In re application: Woronoff, John International App. No. PCT/US2004/005145
Serial No.: 10/588,938 International Filing Date: 20 February 2004
Filed: 08/08/2006
Art Unit: 3654
Examine: Kruer, Stefan
Confirmation No.: 9734
For: A DEVICE FOR MOVING A PLATFORM ALONG ELEVATOR
GUIDE RAILS

PETITION TO HAVE OBJECTIONS WITHDRAWN

Fig-5

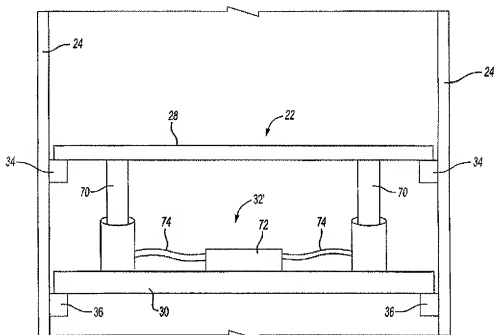
With respect to the use of a pressurized actuator in lieu of an (electrical) drive motor (Page 5, L. 21 – Page 6, L. 3, Fig. 5), as understood, said actuator pushes the upper one of two platform upwards and then, upon evacuation of said pressurized fluid, allows said upper of two platforms to fall until a first holding device (34) engages an associated rail to arrest further downward movement of said upper platform; however, further evacuation of said pressurized fluid, as

understood from the embodiment as depicted, would not result in a lifting of a lower of said two platforms on which actuator is mounted, unless the actuator was of double-acting construction having two pressure chambers in which pressurized fluid can be introduced/evacuated such that a piston of said actuator is forcibly moved upwards and downwards.

The disclosure reviews a conceptual system, thereby enabling/requiring unnecessary interpretation as to a defined scope of the cooperative elements, their structure as well as their interaction.

- With respect to the use of a pressurized actuator in lieu of an (electrical) drive motor (Page 5, L. 21 – Page 6, L. 3, Fig. 5), as understood, said actuator pushes the upper one of two platform upwards and then, upon evacuation of said pressurized fluid, allows said upper of two platforms to fall until a first holding device (34) engages an associated rail to arrest further downward movement of said upper platform; however, further evacuation of said pressurized fluid, as understood from the embodiment as depicted, would not result in a lifting of a lower of said two platforms on which actuator is mounted, unless the actuator was of double-acting construction having two pressure chambers in which pressurized fluid can be introduced/evacuated such that a piston of said actuator is forcibly moved upwards and downwards.

The drawings are objected to under 37 CFR 1.83(a) because they fail to show an arrangement of said primary embodiment utilizing a hand-held drill to forcibly drive a gearing as well as an arrangement to evacuate the pressurized actuator to upwardly move a lower of said two platforms as described in the specification and reviewed above. Any structural detail that is essential for a proper understanding of the disclosed invention should be shown in the drawing. MPEP § 608.02(d). Corrected drawing sheets in compliance with 37 CFR 1.121(d) are required in reply to the Office action to avoid abandonment of the application. Any amended replacement drawing sheet should include all of the figures appearing on the immediate prior version of the sheet, even if only one figure is being amended. The figure or figure number of an amended drawing should not be labeled as "amended." If a drawing figure is to be canceled, the appropriate figure must be removed from the replacement sheet, and where necessary, the remaining figures must be renumbered and appropriate changes made to the brief description of the several views of the drawings for consistency. Additional replacement sheets may be necessary to show the renumbering of the remaining figures. Each drawing sheet submitted after the filing date of an application must be labeled in the top margin as either "Replacement Sheet" or "New Sheet" pursuant to 37 CFR 1.121(d). If the changes are not accepted by the examiner, the applicant will be notified and informed of any required corrective action in the next Office action. The objection to the drawings will not be held in abeyance.

Applicant respectfully disagrees with the Examiner's position. Figure 5

schematically shows an arrangement that is the subject of the Examiner's problem with the disclosure.

Figure 5 schematically shows another example embodiment. In this example, the moving mechanism 32' includes at least one pressurized actuator. In this example, two actuators 70 are shown. The pressurized actuator may be pneumatic or hydraulic, for example. The pressure source of pressurized fluid 72 is coupled using conventional fluid lines 74 to the actuators 70. By appropriately controlling the pressurized source 72, the actuators 70 expand and contract to cause the platforms 28 and 30 to move in a sequential manner because the holding devices

For example, when the actuators 70 are in an expanded position and fluid is evacuated from the actuators to cause them to contract, the second platform 30 is pulled upward toward the first platform 28. Subsequently, when the actuators are filled with pressurized fluid they expand causing the first platform 28 to be pushed upward and away from the second platform 30, which remains in position because of the operation of the holding devices 36.

That description is entirely clear to one skilled in the art as to how an example embodiment like that shown in Figure 5 would operate. There is no “unnecessary interpretation as to a defined scope of the cooperative elements” as suggested by the Examiner. Moreover, the Examiner’s interpretation is directly contrary to the express statements in Applicant’s specification.
